Logos Apparels Ltd. (10917)

06.APRIL.2014

Identified Priority 2 Concerns

1st Priority 2 Concern

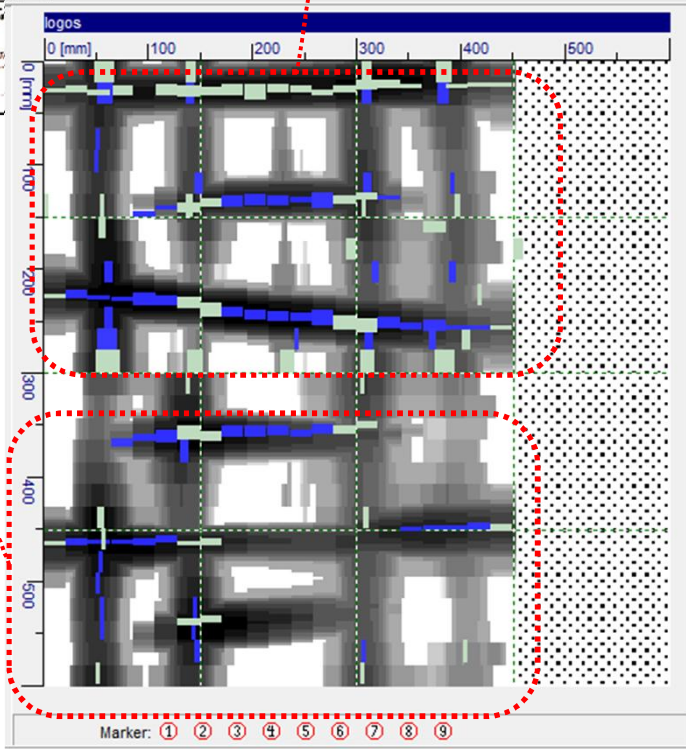
This area shows 5 longitudinal bars.

This column C2 at grid B6 was randomly checked with a Ferros scanning device.

This area shows 4 longitudinal bars.

The column C2 is supposed to have 5 bars each side.

The Ferroskan image shows an inconsistency with the reinforcement configuration between the structural design and the as-built structure.

- Building survey must be taken to verify the system with regard to reinforcement configuration
- Building engineer to verify the system to ensure the structural consistency between design and as-built structure

- Building engineer to check for non-compliance

1st Priority 3 Concern

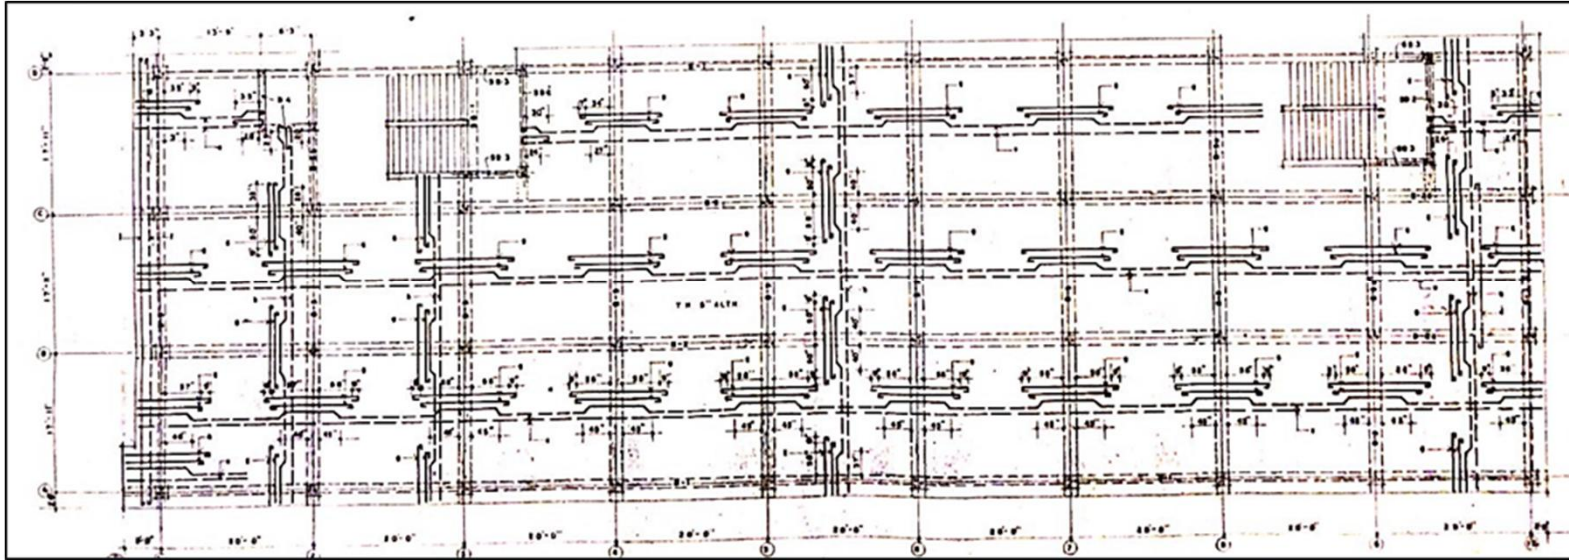
Typical 127mm concrete slab (5in)

- The slab appears to be thinner than what is required. The span/depth ratio of slab = $6090/127 = 47 > 38$
- The design seems to lack a long term deflection analysis consideration.

Very thin slabs could result in excessive long term deflections

- Building Engineer to verify design and check with full compliance to design codes
- Long term deflection criteria to be justified

- If the slabs are found not to comply, then remedial details should be proposed and installed.
